## 1100-500 Belmont 2561 Water Update Kit

This update kit provides individual water relay valves for each handpiece position. Diagrams 1 and 2 display the **original** schematic and configuration. Diagrams 3 and 4 reflect the required changes.

Diagram 4  
Revised schematic, with 3 water relays and removed check valves.

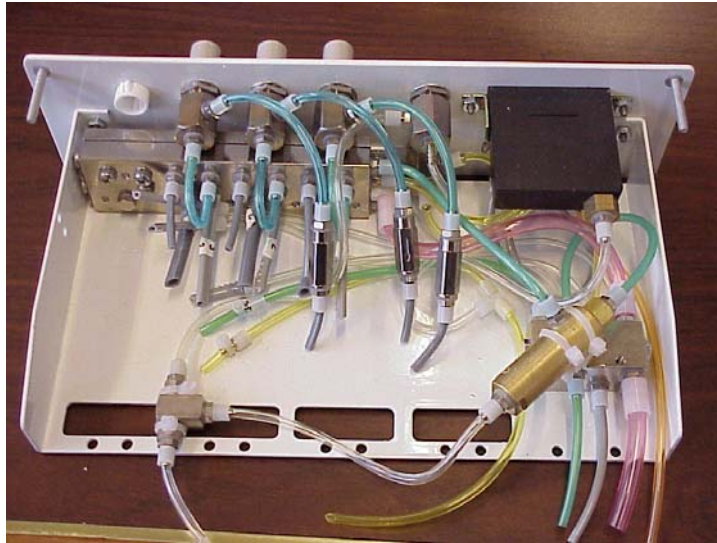
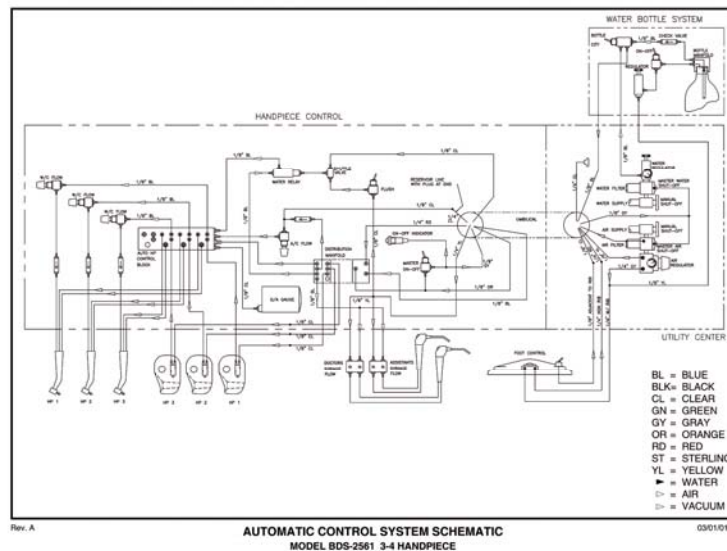
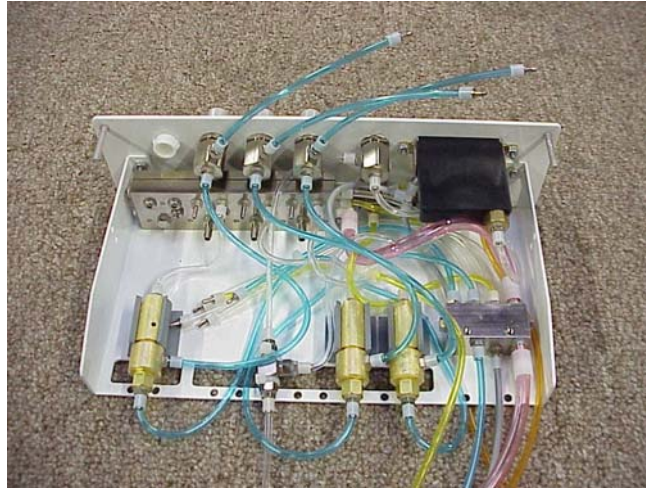
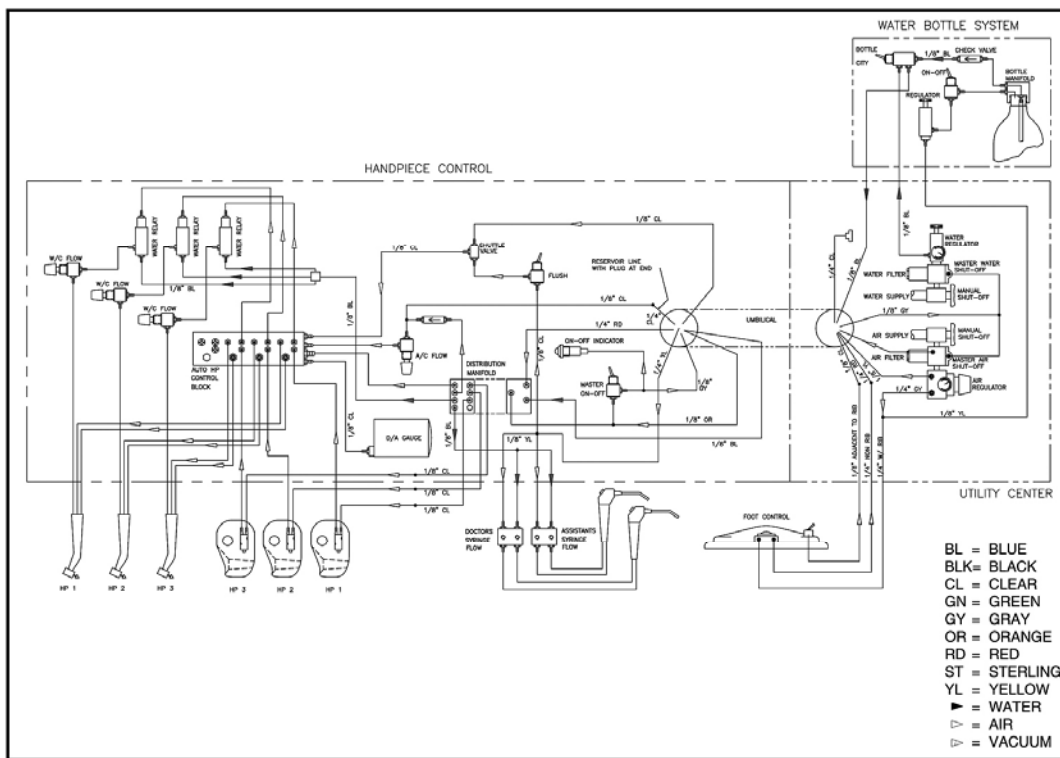
Diagram 3  
With 3 water relay valves and no check valves
